# Cottam Solar Project

### Figure 8.16.9: Landscape and Ecology Mitigation and Enhancement Plan – Cottam 3B Revision A

PINS reference: EN010133  
Document reference: EX1/C6.4.8.16.9\_A  
APFP Regulation 5(2)(a)

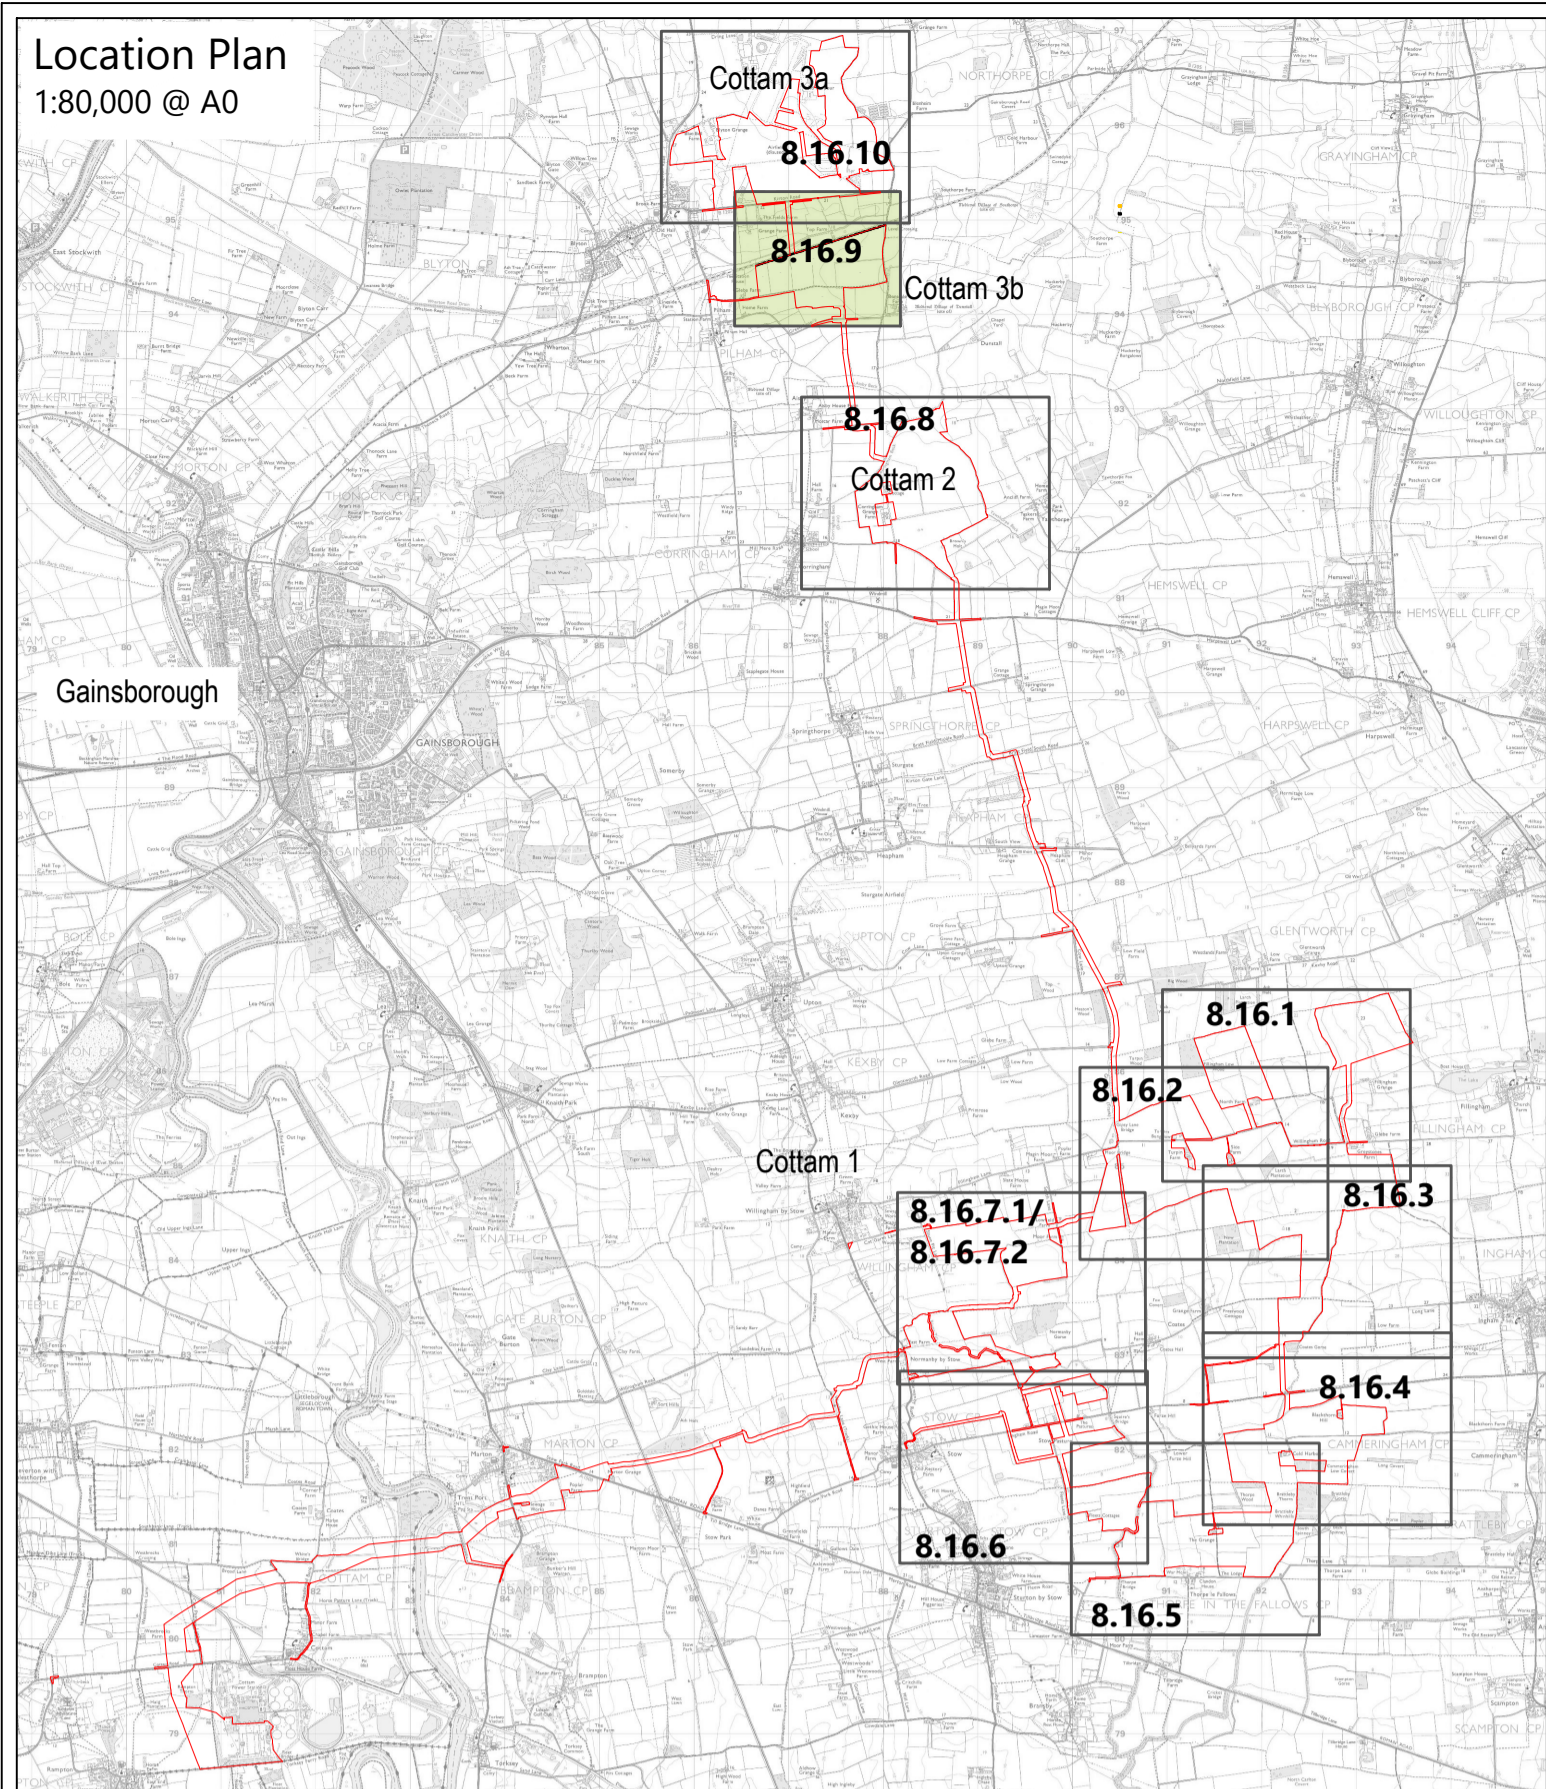
Figure Reference	Page	Description of Changes	Reason for Revision
Figure 8.16.9	3	Change to spelling of 'enhancement'. Offset calculations from drains. Additional Hedgerows to be removed.	For clarity and consistency. To correct a typo.
